# Access Audit Site Report

**Village Creek State Park**

**Accessibility Evaluation**

**Inspection Date: 08/19/2022**

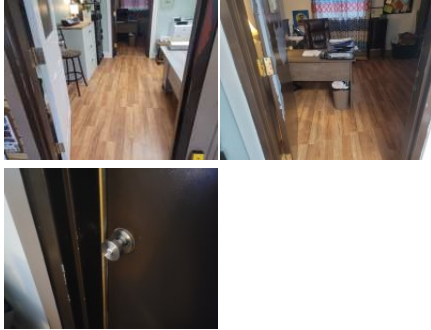
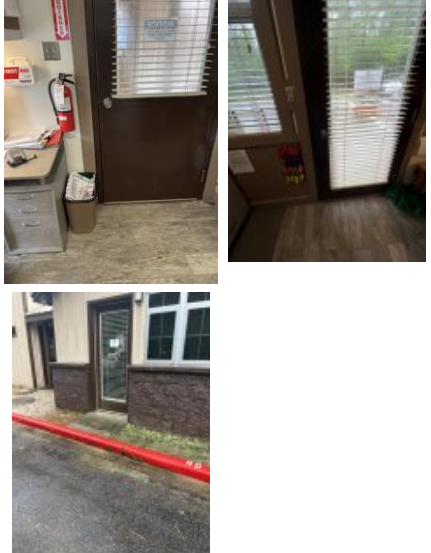
Finding Number	Area Description	Lat/Long	Finding	As Built	Recommendation	Citation	Photos	Figure
3	Headquarters Area: HQ - Exterior Accessible Route	[30.2505129 , -94.178796 2]	The running slope of walking surfaces shall not be steeper than 1:20.	9.3% and 6.8% connecting to parking	Correct running slope along the AR to max 5%.	2015 ABAAS Section: 403.3 2012 TAS Section: 403.3 2010 ADAS Section: 403.3		
4	Headquarters Area: HQ - Exterior Accessible Route	[30.2505264 , -94.178732 2]	The spout for the drinking fountain is too high. Spout outlets shall be 36 inches maximum above the finish floor or ground.	37.25" AFF	Remount fountain so spout outlet is max 36" AFF.	2015 ABAAS Section: 602.4 2012 TAS Section: 602.4 2010 ADAS Section: 602.4		
5	Headquarters Area: HQ - Exterior Accessible Route	[30.2504874 , -94.178730 9]	An item or items project more than 4 inches into the circulation path. Wall-mounted objects that have leading edges between 27 inches and 80 inches from the floor must not project more than 4 inches into the circulation path. Protruding objects that extend to the floor or within 27 inches of the floor are cane detectable and are therefore not hazardous. Where it is necessary or desirable to have objects protrude from the wall, a manner of cane detection must be provided.	Fountains project into route	Relocate protruding objects or place cane detectable warning or bollard at foot of item.	2015 ABAAS Section: 307.2 2012 TAS Section: 307.2 2010 ADAS Section: 307.2

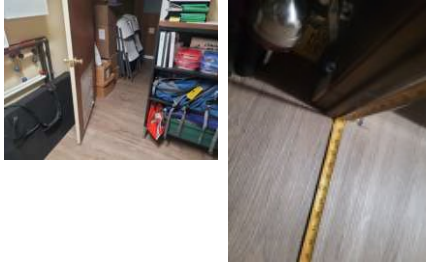
25	Headquarters Area: HQ - Staff Restroom	[30.2505308 , -94.178727 8]	The grab bar height and/or spacing fails. Grab bars must be mounted between 33" and 36" to the top of the gripping surface. There must be 1.5" of clearance between the grab bar and the wall. There must be a minimum of 1.5" of clearance below and minimum 12" above the grab bar to any dispenser or other obstruction.	Both grab bars 36.5" AFF	Remount grab bars in accessible stall to 33" to 36" above the finished floor (AFF).	2015 ABAAS Section: 609.3, 609.4  2012 TAS Section: 609.4, 609.3  2010 ADAS Section: 609.3, 609.4

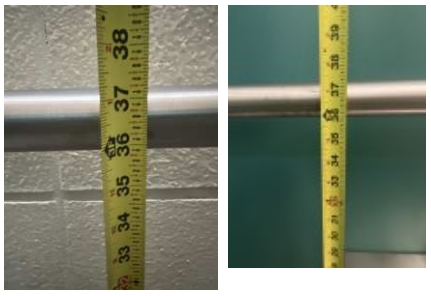
100	Hilltop Camping Area: Hilltop - Men's Restroom	[30.25099, -94.17708]	The bench is not deep enough or long enough or is missing. Benches shall be provided having seats that are 42 inches long minimum and 20 inches deep minimum and 24 inches deep maximum. The bench shall provide for back support or shall be affixed to a wall. Back support shall be 42 inches (1065 mm) long minimum and shall extend from a point 2 inches (51 mm) maximum above the seat surface to a point 18 inches (455 mm) minimum above the seat surface. Back support shall be 2½ inches (64 mm) maximum from the rear edge of the seat measured horizontally. The top of the bench seat surface shall be 17 inches (430 mm) minimum and 19 inches (485 mm) maximum above the finish floor or ground. Clear floor or ground space complying with 305 shall be provided and shall be positioned at the end of the bench seat and parallel to the short axis of the bench	Narrow bench in restroom, bench in shower larger but lacks CGS and would need to be relocated out of shower	Replace bench in dressing area with one having a seat depth of 20" to 24" deep, 42" long, affixed to the wall or having a back and mounted 17" to 19" AFF and provide required clear floor space on the short axis of the bench.	2012 TAS Section: 903.4, 903.2, 903.3, 903.5  2010 ADAS Section: 903.4, 903.2, 903.3, 903.5

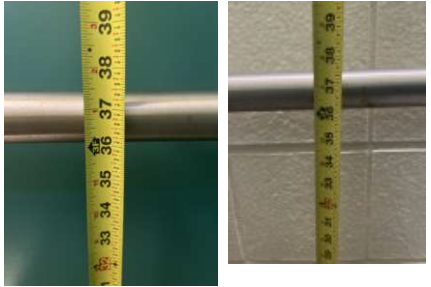
103	Hilltop Camping Area: Hilltop - Men's Restroom	[30.2510621, -94.1771384]	The spout for the drinking fountain is too high. Spout outlets shall be 36 inches maximum above the finish floor or ground.	Spout 37.5" above ground surface	Remount fountain so spout outlet is max 36" AFF.	2015 ABAAS Section: 602.4  2012 TAS Section: 602.4  2010 ADAS Section: 602.4		
104	Hilltop Camping Area: Hilltop - Men's Restroom	[30.251085, -94.1771438]	The spout is not positioned correctly from the vertical support. The spout shall be located 15 inches minimum from the vertical support and 5 inches maximum from the front edge of the unit, including bumpers.	12.5" from vertical support	Remount or replace fountain to provide 15" from vertical support to the spout	2015 ABAAS Section: 602.5  2012 TAS Section: 602.5  2010 ADAS Section: 602.5

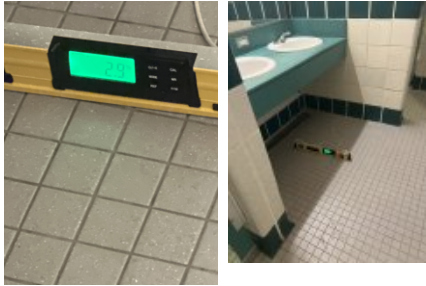
111	Hilltop Camping Area: Hilltop - Men's Restroom	[30.2510521, -94.177077]	The water and drain pipes under the lavatory are not adequately insulated. Water supply and drain pipes under lavatories and sinks shall be insulated or otherwise configured to protect against contact. There shall be no sharp or abrasive surfaces under lavatories and sinks.	Lacks insulation	Insulate exposed pipes under one sink.	2015 ABAAS Section: 606.5 2012 TAS Section: 606.5 2010 ADAS Section: 606.5

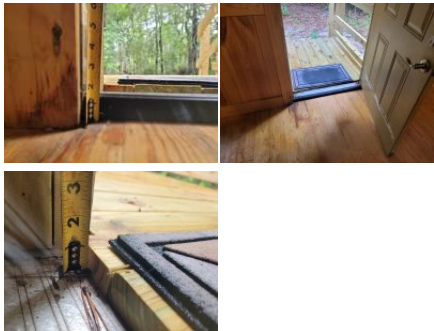
Finding Number	Area Description	Lat/Long	Finding	As Built	Recommendation	Citation	Photos	Figure
129	Youth Group Campground: Group Parking	[30.2515994 , -94.175544]	There is no accessible route to the pet waste supplies, signage and trail. At least one accessible route shall connect accessible buildings, accessible facilities, accessible elements, and accessible spaces that are on the same site.	Lacks route to pet waste supplies, signage and trail	Create an accessible route with crushed stone or other outdoor material from parking or walkway to pet waste supplies, signage and trail.	2015 ABAAS Section: F206.2.2  2012 TAS Section: 206.2.2  2010 ADAS Section: 206.2.2		
130	Youth Group Campground: Group Parking	[30.2515826 , -94.175634]	There are no or not enough accessible parking stalls. Each lot where parking is provided for the public as clients, guests or employees, shall provide accessible parking and shall be located on the shortest accessible route of travel from adjacent parking to an accessible entrance. There are a total of 10 parking stalls in the parking lot that could be reasonably associated with this facility. There should be a minimum of 1 accessible stalls with a minimum of 1 being designed as van accessible.	Lacks accessible parking	Create one or more 8' accessible parking stalls, with one 5' adjacent access aisle, with proper signage and striping based on the total number of stalls.	2015 ABAAS Section: F208.2  2012 TAS Section: 208.2  2010 ADAS Section: 208.2

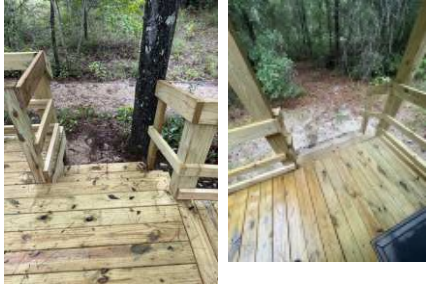
Finding Number	Area Description	Lat/Long	Finding	As Built	Recommendation	Citation	Photos	Figure
148	Beechwood Day Use Area: Day Use - Cabin	[30.25486, -94.17305]	Treads shall be 11 inches (280 mm) deep minimum and uniform	Stair treads are 9" deep	Correct tread depth on stairs to 11" minimum and consistent, leave as is if technically infeasible.	2015 ABAAS Section: 504.2 2012 TAS Section: 504.2 2010 ADAS Section: 504.2		
149	Beechwood Day Use Area: Day Use - Cabin	[30.25486, -94.17305]	Open risers are not permitted.	Open risers	Install kick plates on all stairs or replace with ones having closed risers.	2015 ABAAS Section: 504.3 2012 TAS Section: 504.3 2010 ADAS Section: 504.3		
150	Beechwood Day Use Area: Day Use - Cabin	[30.25486, -94.17305]	The stripe on the stair tread does not contrast adequately with the stair tread. Exterior and interior stairs are recommended to have the upper approach and lower treads marked by a stripe providing clear visual contrast.	Stairs lack visual contrast	Install contrasting strip along front 2" of each tread. The stripe shall be a minimum of 2 inches wide to a maximum of 4 inches wide placed parallel to, and not more than 1 inch from, the nose of the step or upper approach. The stripe shall extend the full width of the step or upper approach and shall be of material that is at least as slip resistant as the other treads of the stair. A painted stripe shall be acceptable. Grooves shall not be used to satisfy this requirement.	2015 ABAAS Section: Advisory 504.4 2012 TAS Section: 504.4 Advisory 2010 ADAS Section: 504.4

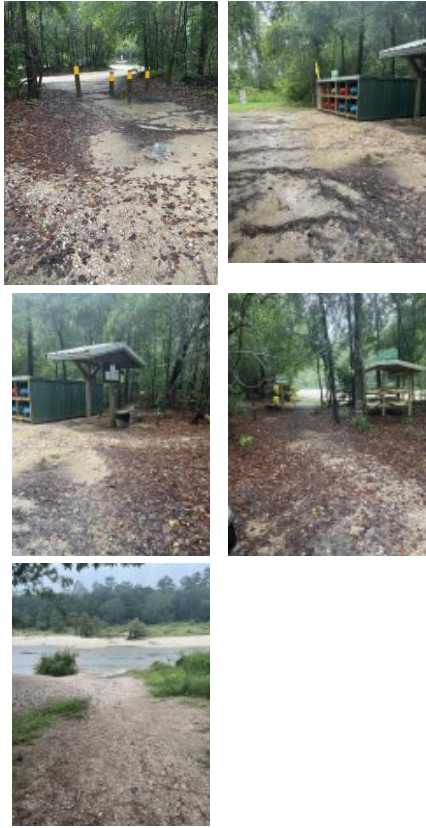
Finding Number	Area Description	Lat/Long	Finding	As Built	Recommendation	Citation	Photos	Figure
163	Beechwood Day Use Area: Day Use - Cabin	[30.2550869, -94.172966]	The self closing faucet controls do not stay open for a minimum of 10 seconds. Faucet controls and operating mechanisms shall be operable with one hand and shall not require tight grasping, pinching or twisting of the wrist. The force required to activate controls shall be no greater than 5 lb. Lever-operated, push-type and electronically controlled mechanisms are examples of acceptable designs. Self-closing valves are allowed if the faucet remains open for at least 10 seconds.	faucet has quick shut off	Adjust timing of sink faucets to remain on for min. 10 seconds.	2015 ABAAS Section: 606.4 2012 TAS Section: 606.4 2010 ADAS Section: 606.4		
164	Beechwood Day Use Area: Day Use - Cabin	[30.2550869, -94.172966]	Where a high forward reach is over an obstruction, the clear floor space shall extend beneath the element for a distance not less than the required reach depth over the obstruction. The high forward reach shall be 48 inches (1220 mm) maximum where the reach depth is 20 inches (510 mm) maximum. Where the reach depth exceeds 20 inches (510 mm), the high forward reach shall be 44 inches (1120 mm) maximum and the reach depth shall be 25 inches (635 mm) maximum. Where a clear floor or ground space allows a parallel approach to an element and the high side reach is over an obstruction, the height of the obstruction shall be 34 inches (865 mm) maximum and the depth of the obstruction shall be 24 inches (610 mm) maximum. The high side reach shall be 48 inches (1220 mm) maximum for a reach depth of 10 inches (255 mm) maximum. Where the reach depth exceeds 10 inches (255 mm), the high side reach shall be 46 inches (1170 mm) maximum for a reach depth of 24 inches (610 mm) maximum.	Soap 49.5"	Lower soap dispenser to max 44" above the finished floor (AFF) for a forward reach over counter.	2015 ABAAS Section: 308.2.1, 308.3.2 2012 TAS Section: 308.2.1, 308.3.2 2010 ADAS Section: 308.2.1, 308.3.2
